44473A-01**S E R V I C E N O T E**Supersedes:
NONE**44470A** 10 channel multiplexer module for 3499A/B. Includes a screw terminal block**44471A** 10-channel General Purpose Relay for 3499A/B. Includes a screw terminal block**44473A** 4x4 Matrix Module for 3499A/B. Includes a screw terminal block**44474A** 16-bit Digital I/O Module for 3499A/B. Includes a screw terminal block**Serial Numbers:**

Defective connectors shipped with 44470A, 44471A, 44473A, 44474A

Figure 2: Good Connector with alternating pins on top and bottom

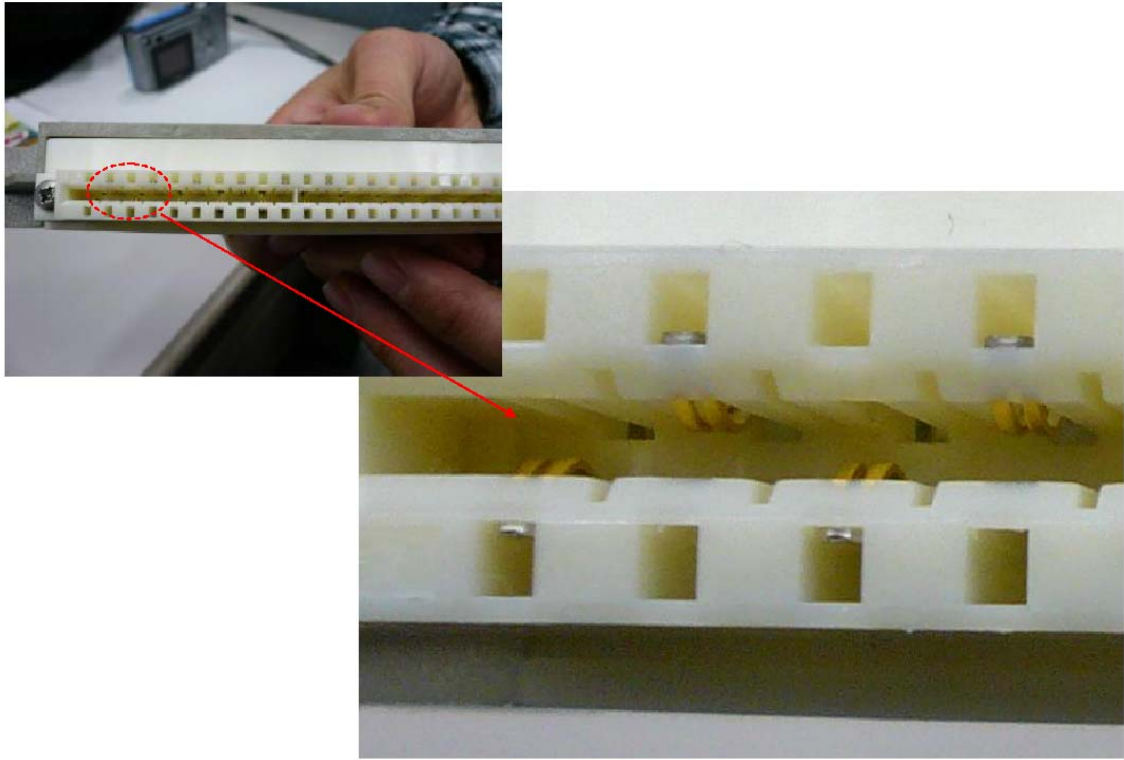
The 44470A, 44471A, 44473A, and 44474A products consist of a main relay plug in module and a removable terminal block (see Figure 1). These are plug in modules for the card cage mainframes 3488A, 3499A, 3499B, and 3499C. The main relay card contains the serial number. The removable terminal module does not contain a serial number. A visual inspection of the connector in the removable terminal block is necessary to determine if a defective connector is present. All white colored connectors are good and have pins that alternate top to bottom (see Figure 2). A black colored connector is bad if it contains all pins on one side of the connector (see Figure 3). A black colored connector is good if it contain pins that alternate top to bottom (not pictured).
